Assessment of Dam Safety

Coal Combustion Surface Impoundments (Task 3)

FirstEnergy Generation
Corporation

Bruce Mansfield
Power Plant
Little Blue Run Dam
Shippingport, Pennsylvania

PROJECT NO.
20085.8000
DATE: 02/2010
FIGURE 11A

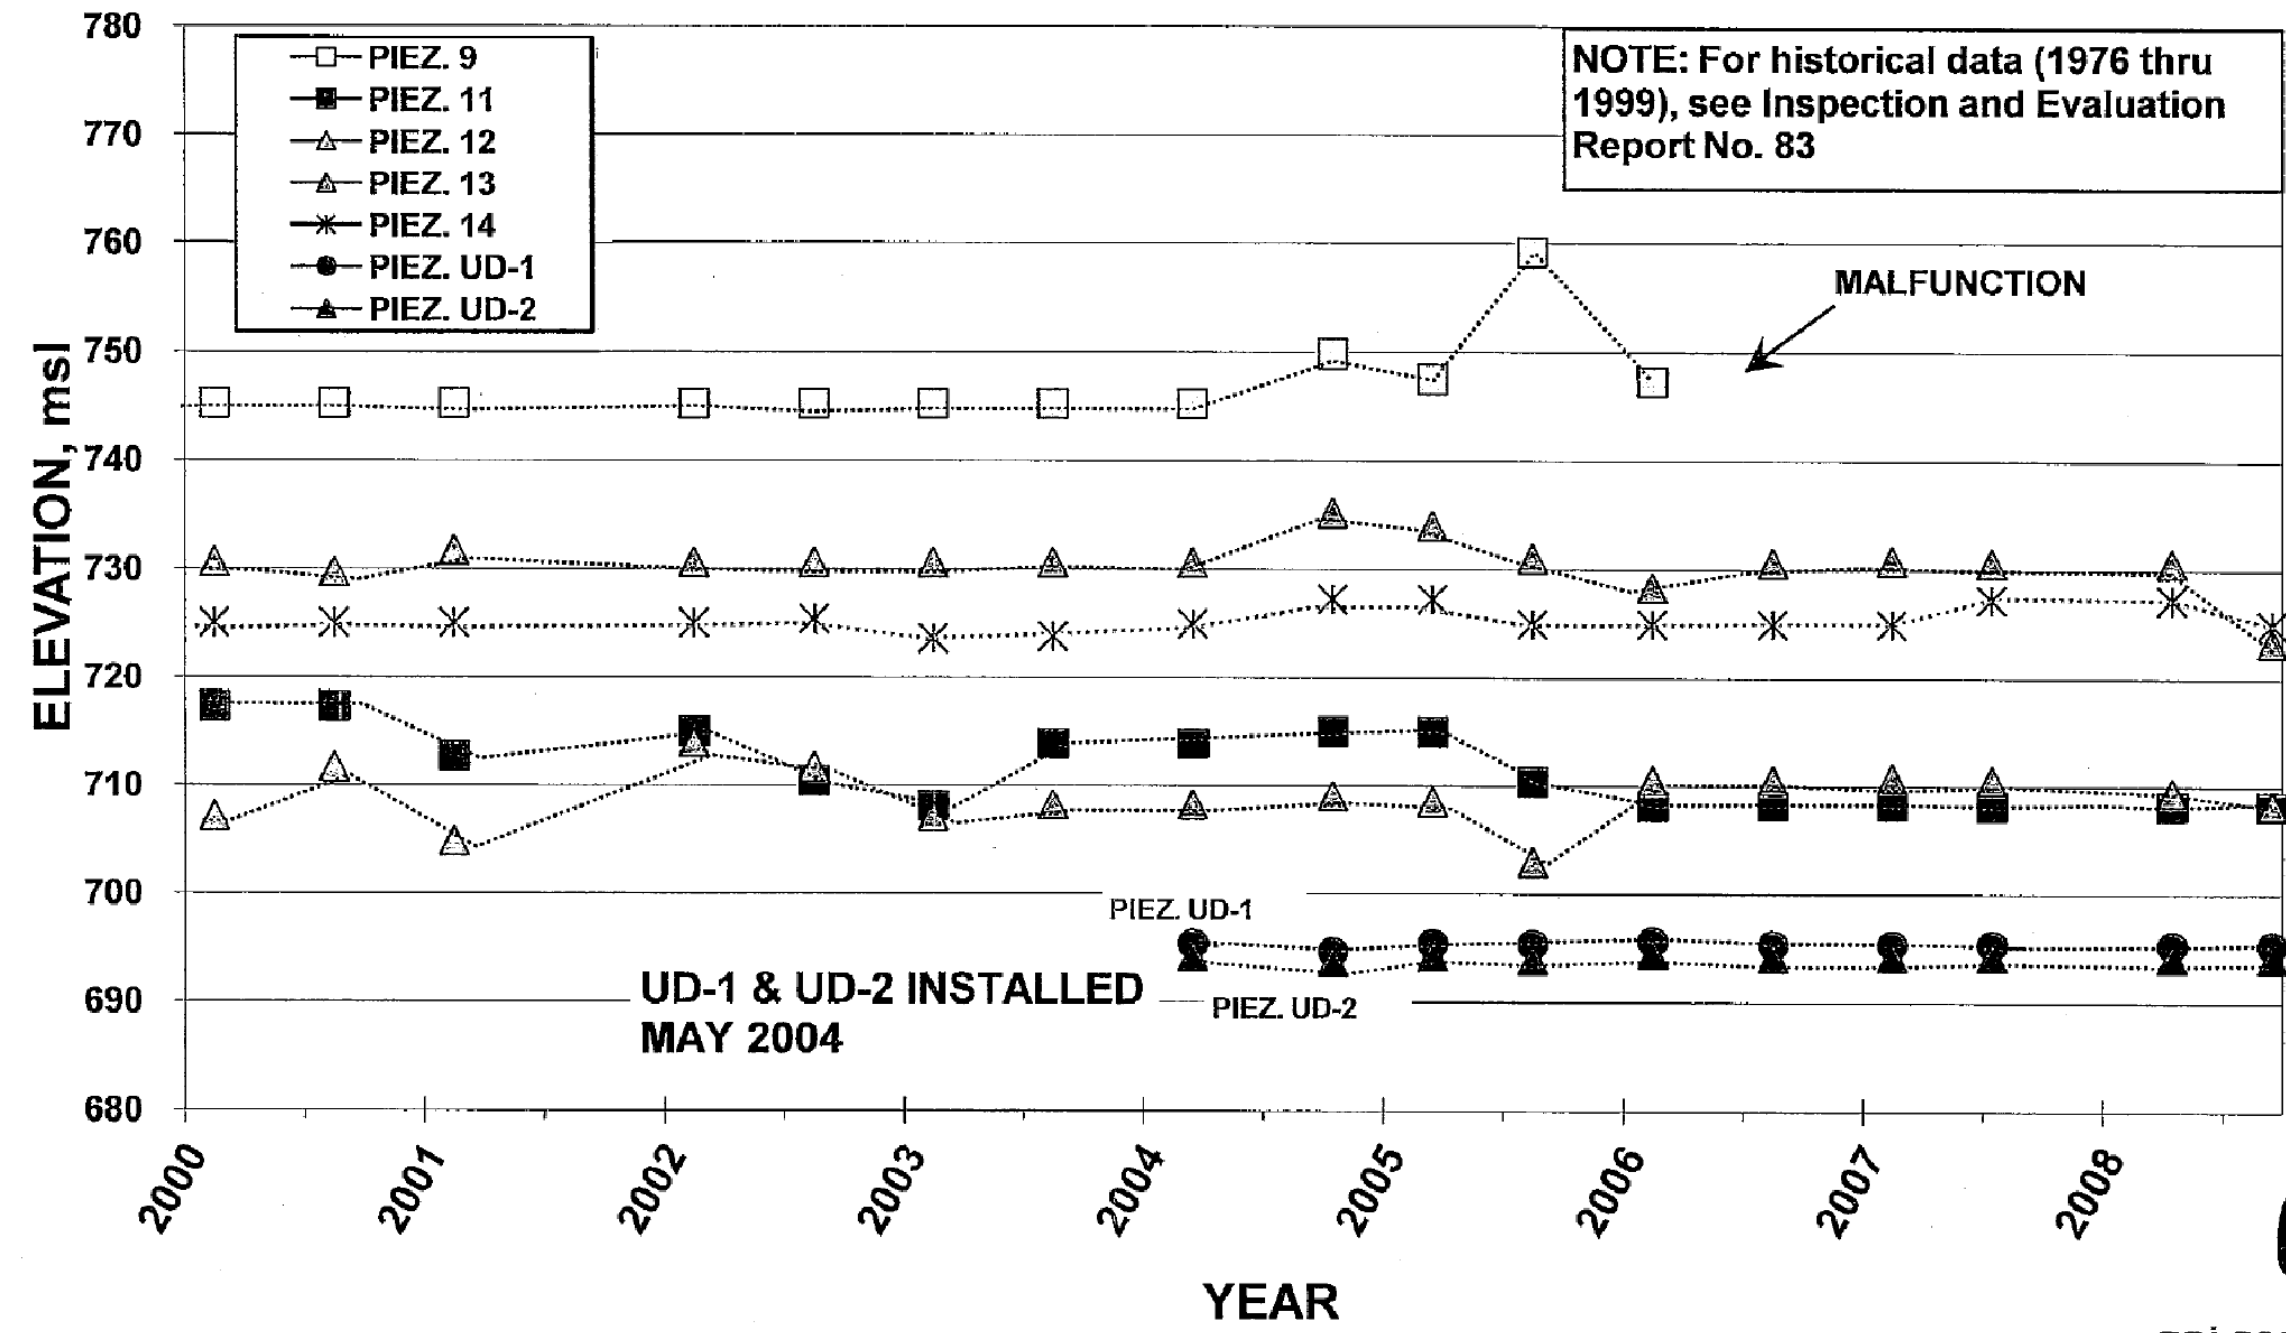
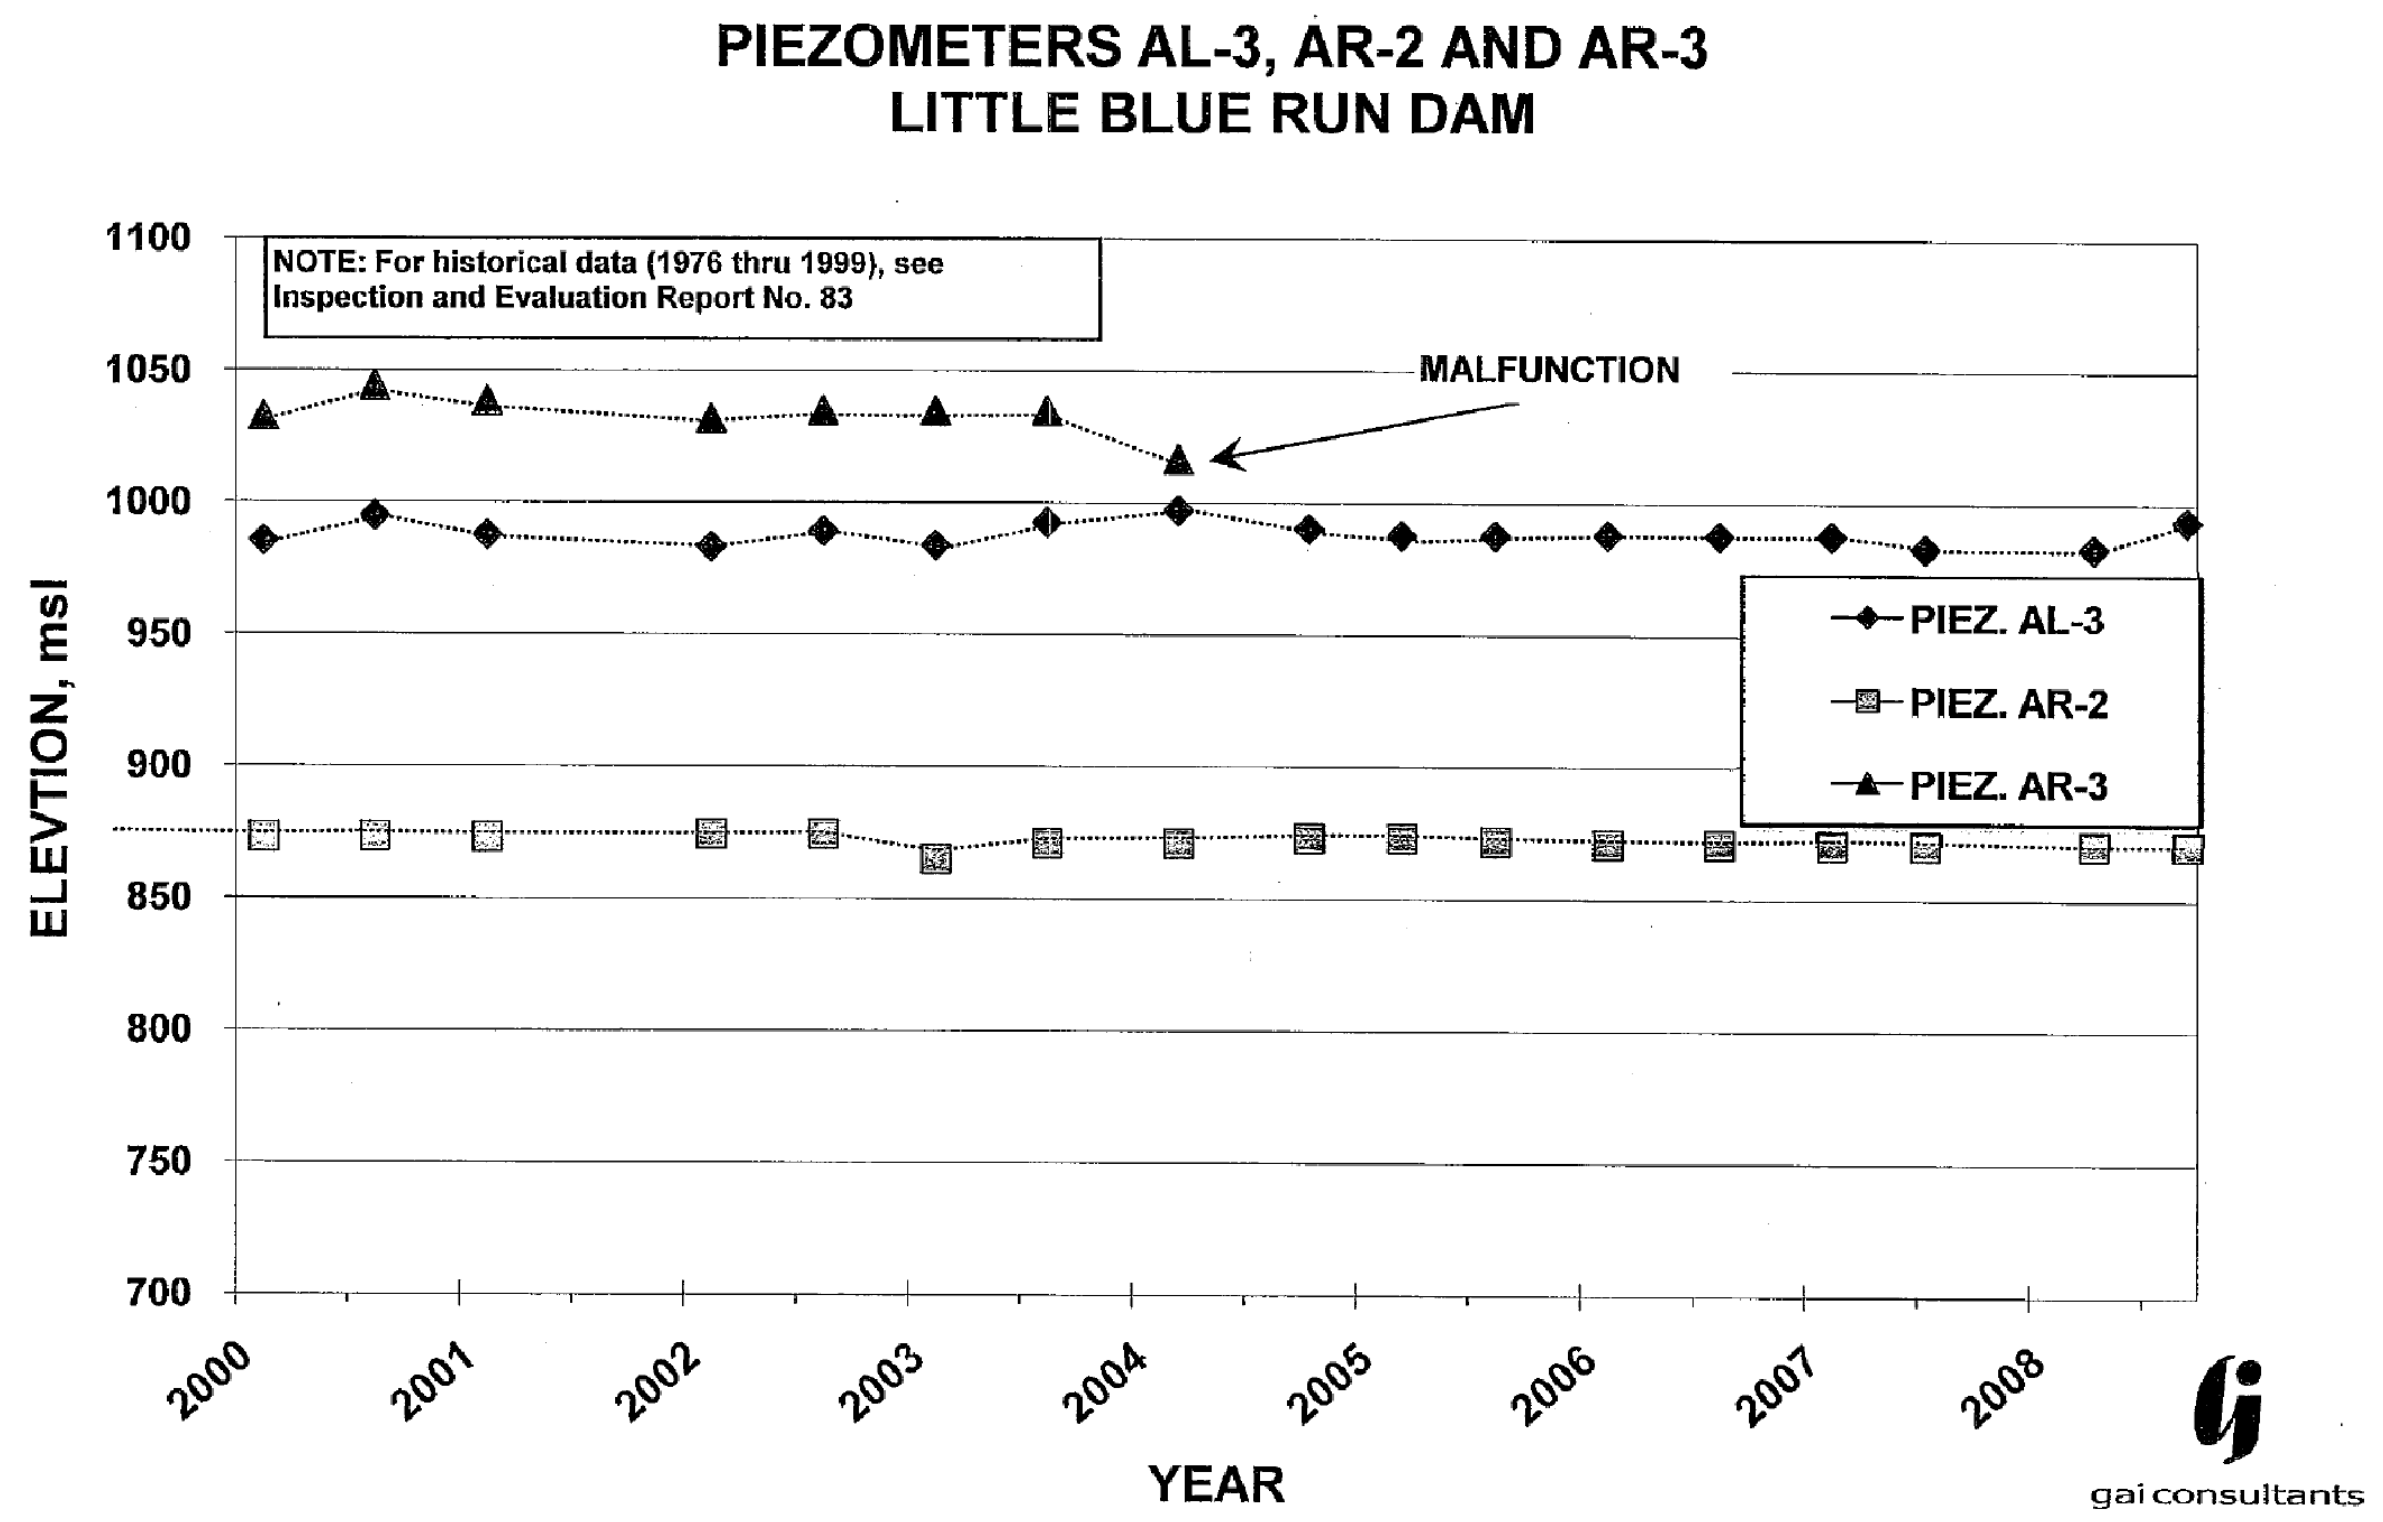
- Piezometers AL-3 and AR-2 monitor pore pressures near claystone interfaces, which is considered to be relatively weak zones within the abutment foundation. Piezometer AL-3 showed a sharp increase in pore pressure from the previous reading. Piezometer AR-2 showed no change in pore pressure from the previous readings. It was noted that both piezometers yield data below their specified limits but the piezometers continue to be suspect.

- Open-tube piezometers (well points) UD-1 and UD-2 monitor the hydrostatic water elevation in the embankment filter blanket/underdrain system. Both well points showed no change from the previous readings and the current data indicates normal conditions within the underdrain system.

PROJECT NO.
20085.8000
DATE: 02/2010
FIGURE 6

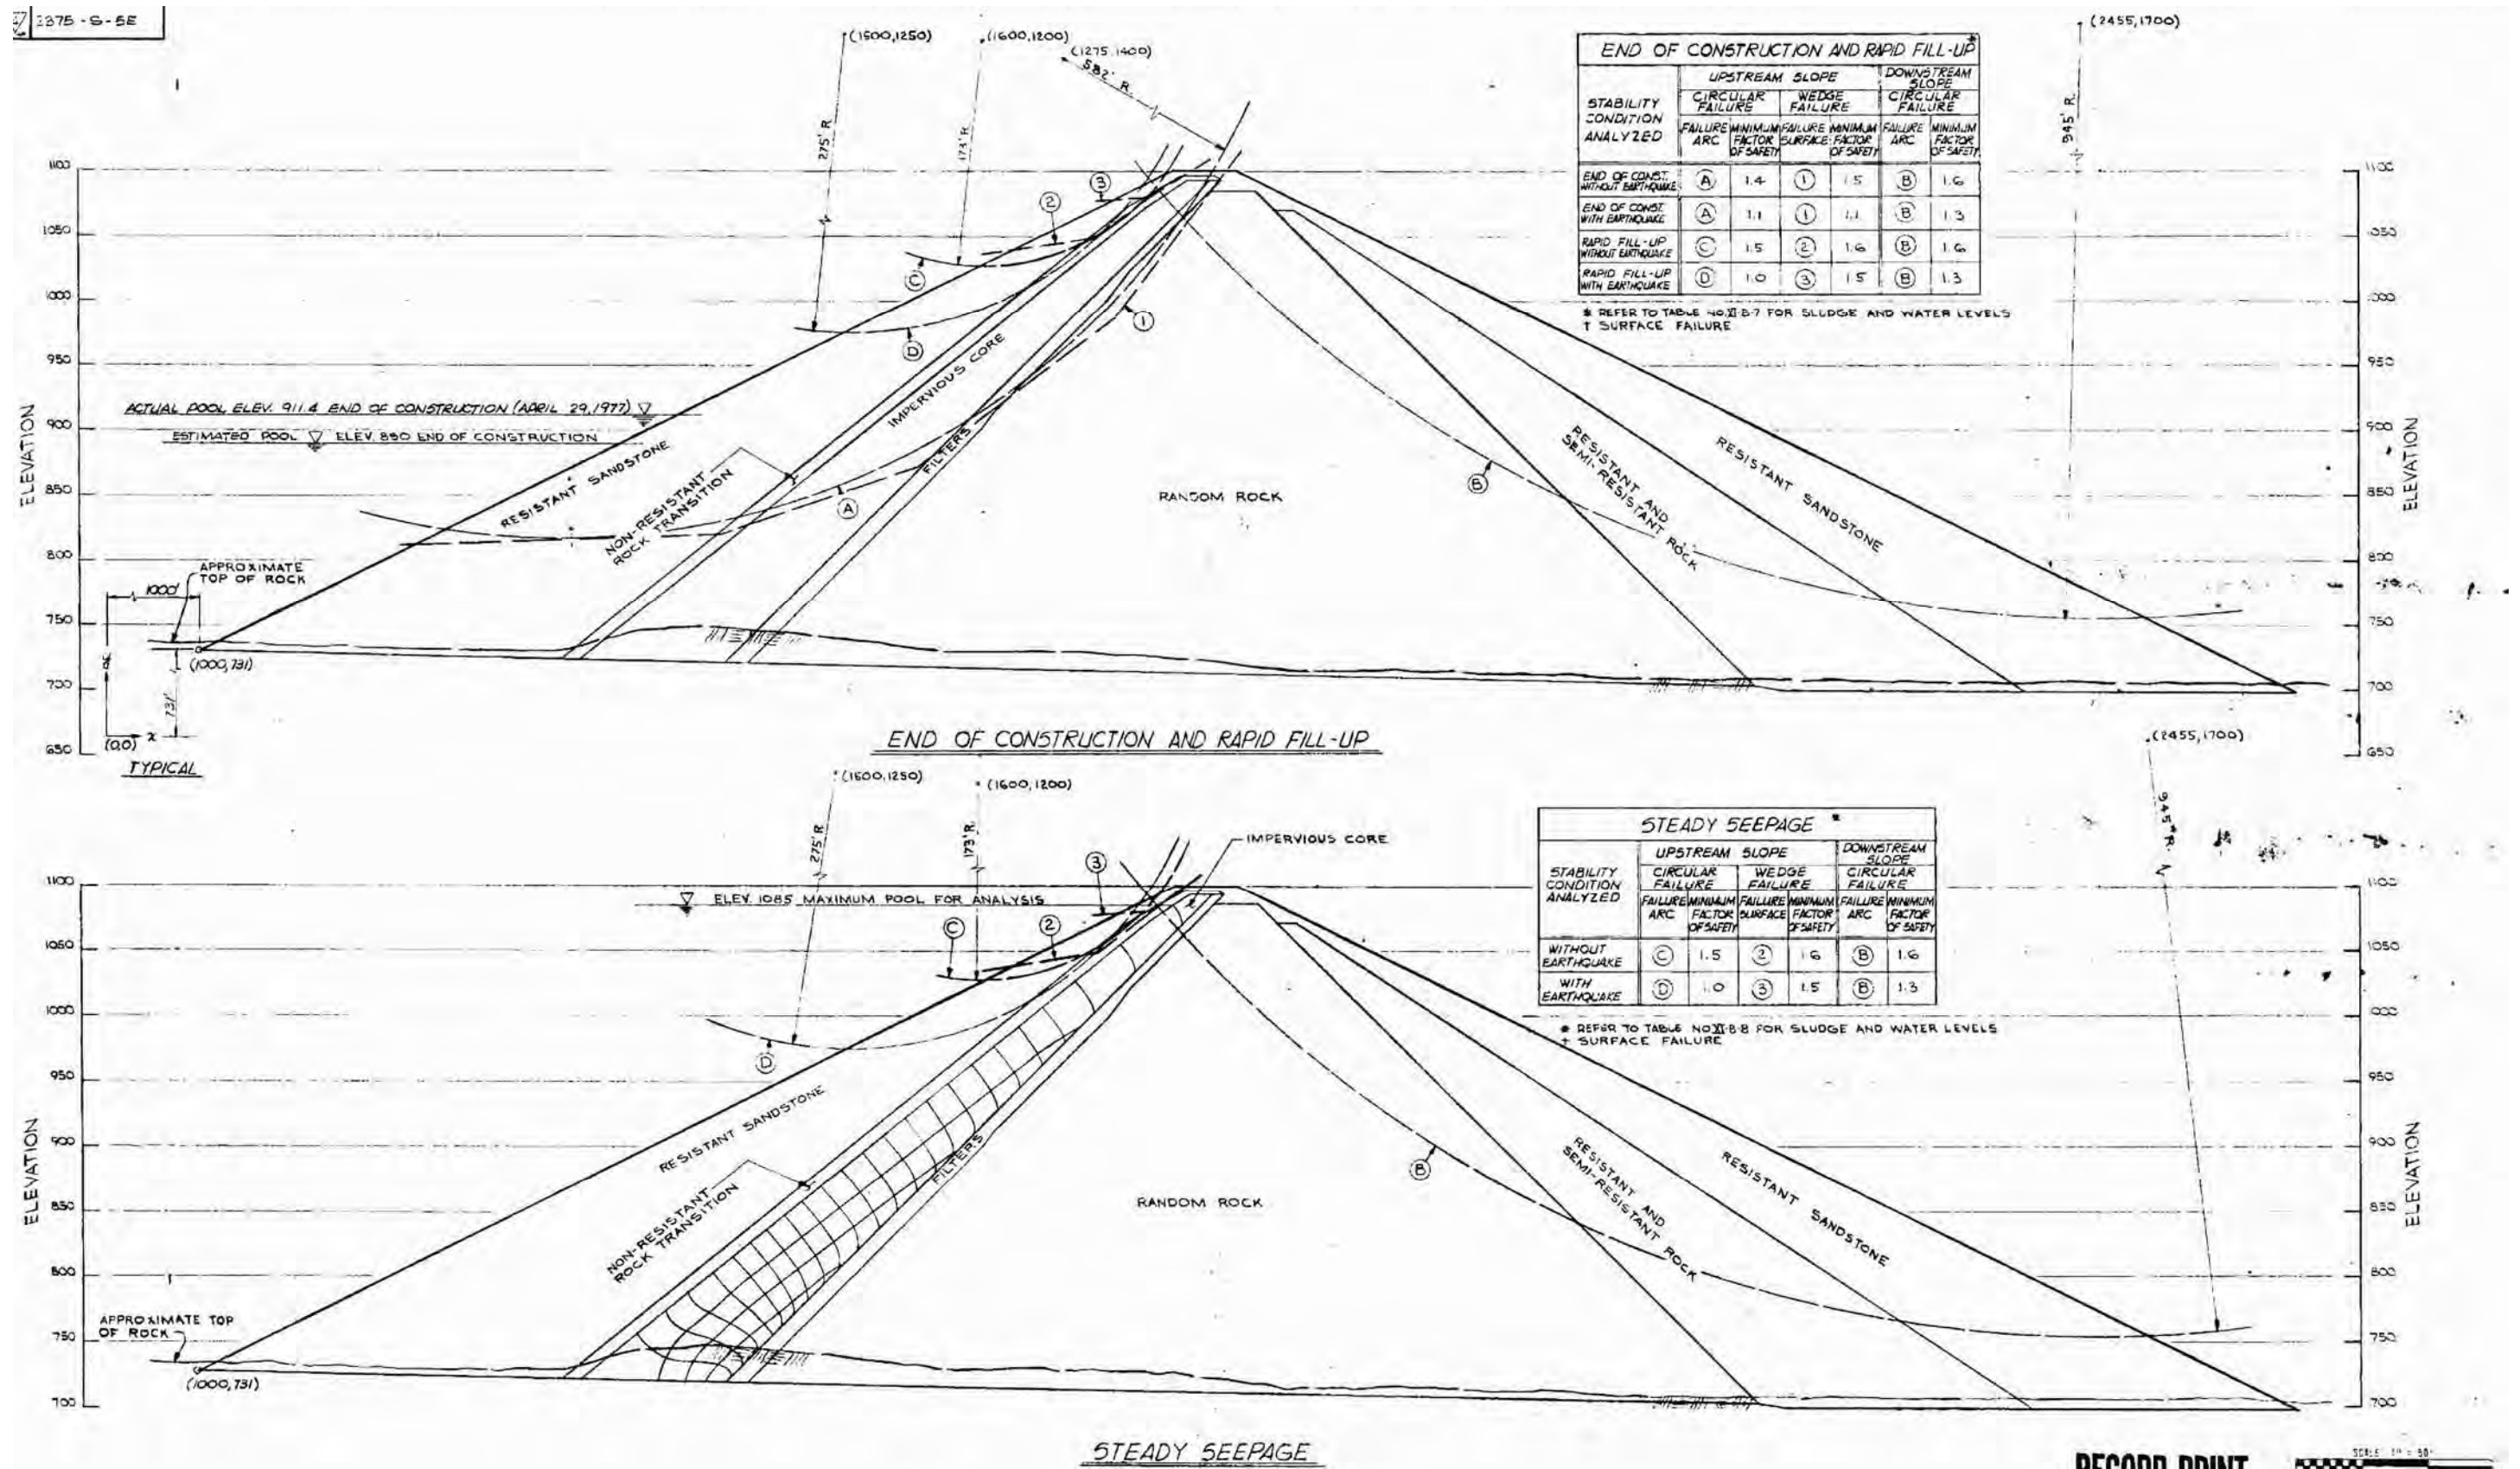
The 1977 As-Built Drawings for the Little Blue Run Dam show engineering analyses results for stability. Figure 6 and Figure 7 show the cross sections modeled and the corresponding results.
